San Joaquin County Office of Emergency Services "*SJ  
County Flood Contingency Map, RD 2064, 2075, 2094 &  
2096, SJ River East Bank*" dated April 2011

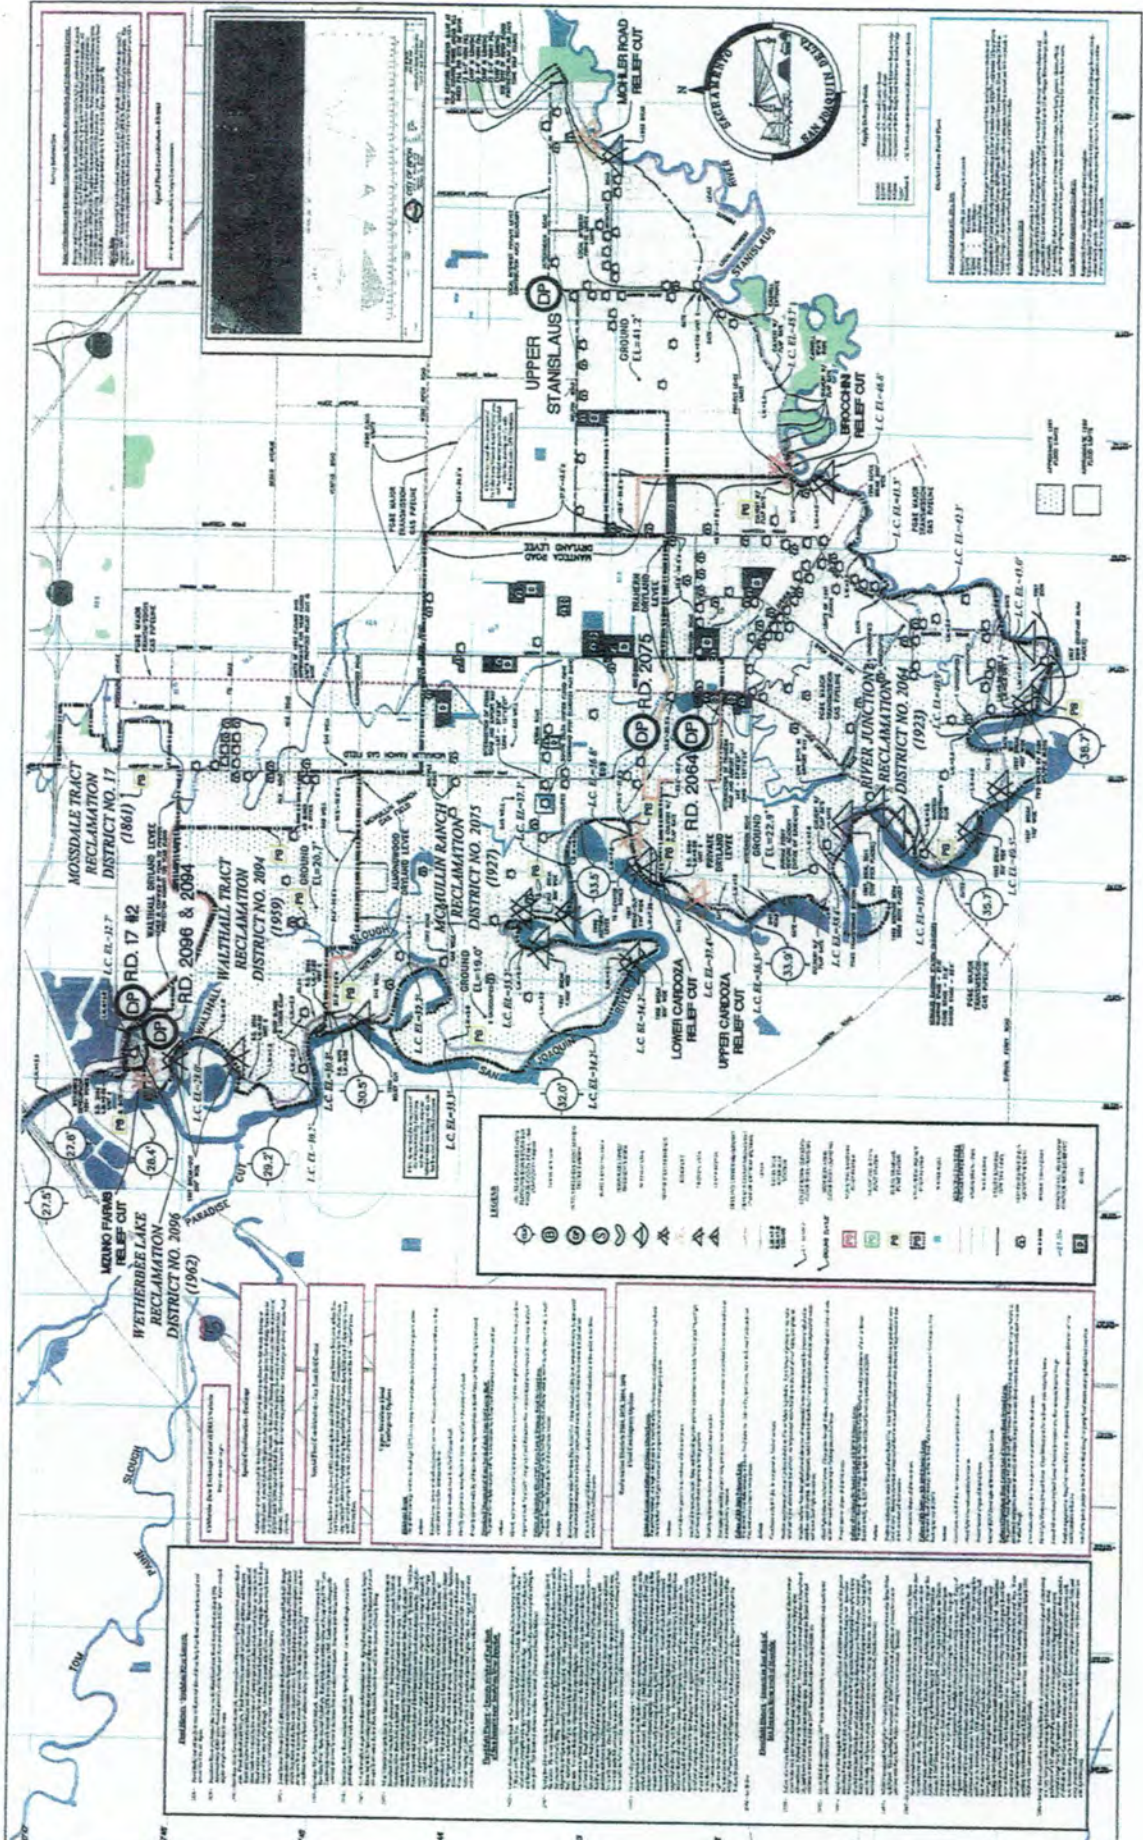
Further, the 2011 San Joaquin County Office of Emergency Services Flood Contingency Map (See Exhibit "3") clearly demonstrates the extent that south Manteca was impacted by flood waters in 1997.

The map includes a contour line indicating the extent that 1997 flood waters reached with the understanding that flood water impact was limited in its extent due to a relief cut being made to the levee in the area south of the Turtle Beach Resort area.

With this in mind, NU's comment is to request that consideration be made to construct gate opening/closure structures to be put in place at the Turtle Beach relief cut levee location area as detailed on pages 4-11 and 4-13 of the San Joaquin River Basin Lower San Joaquin River Feasibility Report. (See Exhibit "12")

Figure 3-8. Alternative 7.

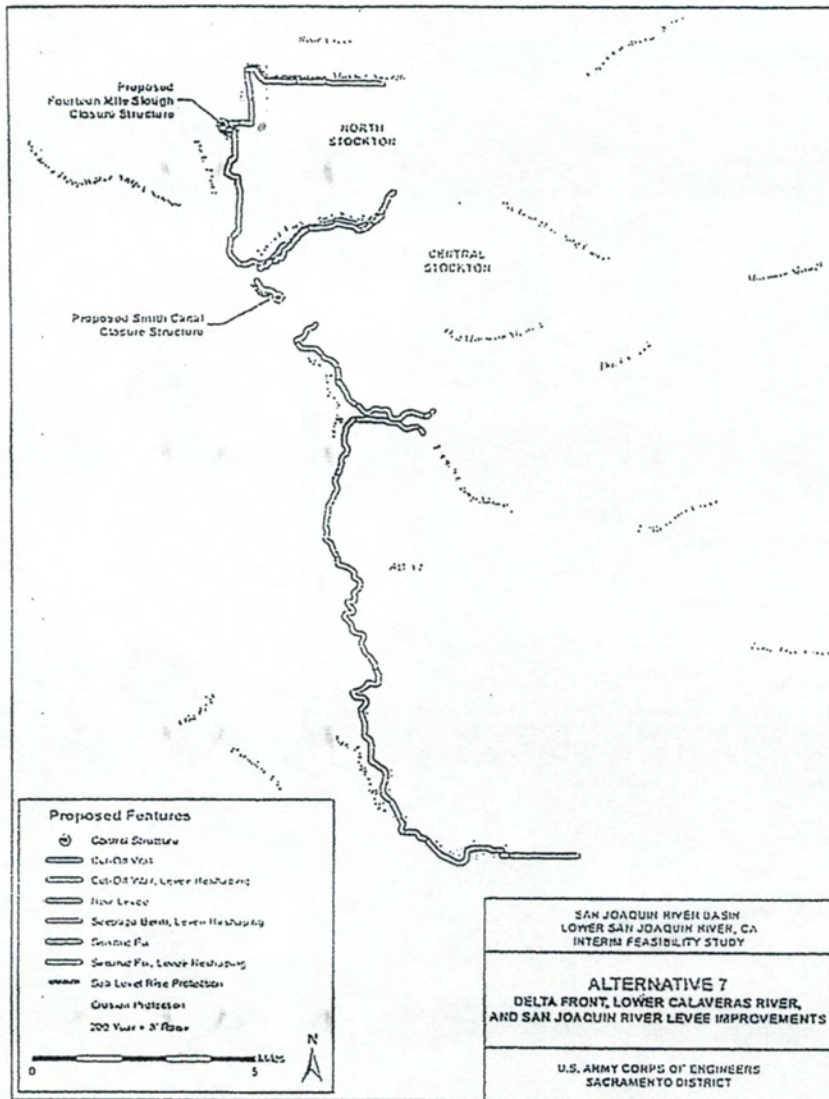
MY RECOMMENDATION IS TO INSTALL A SUBDRAIN SYSTEM ON THE INSIDE TOE OF THE LEVEE WHICH WOULD MAINTAIN THE GROUNDWATER LEVEL AT LEAST 5 FEET BELOW THE BOTTOM OF THE ROOT ZONE OF THE ALMOND TREES. THE SYSTEM WOULD INCLUDE A GRAVEL INTERCEPTOR TRENCH TO WITHIN NOMINALLY 3 FEET OF THE ORIGINAL GROUND SURFACE WITH THE GRAVEL ENCAPSULATED IN FILTER FABRIC AND A PERFORATED COLLECTOR PIPE IN THE BASE OF THE GRAVEL. A DEDICATED PUMP WOULD LIFT THE COLLECTED WATER FOR DISPOSAL ELSEWHERE. THE PUMP WOULD ACTIVATE AUTOMATICALLY BY FLOAT CONTROL.
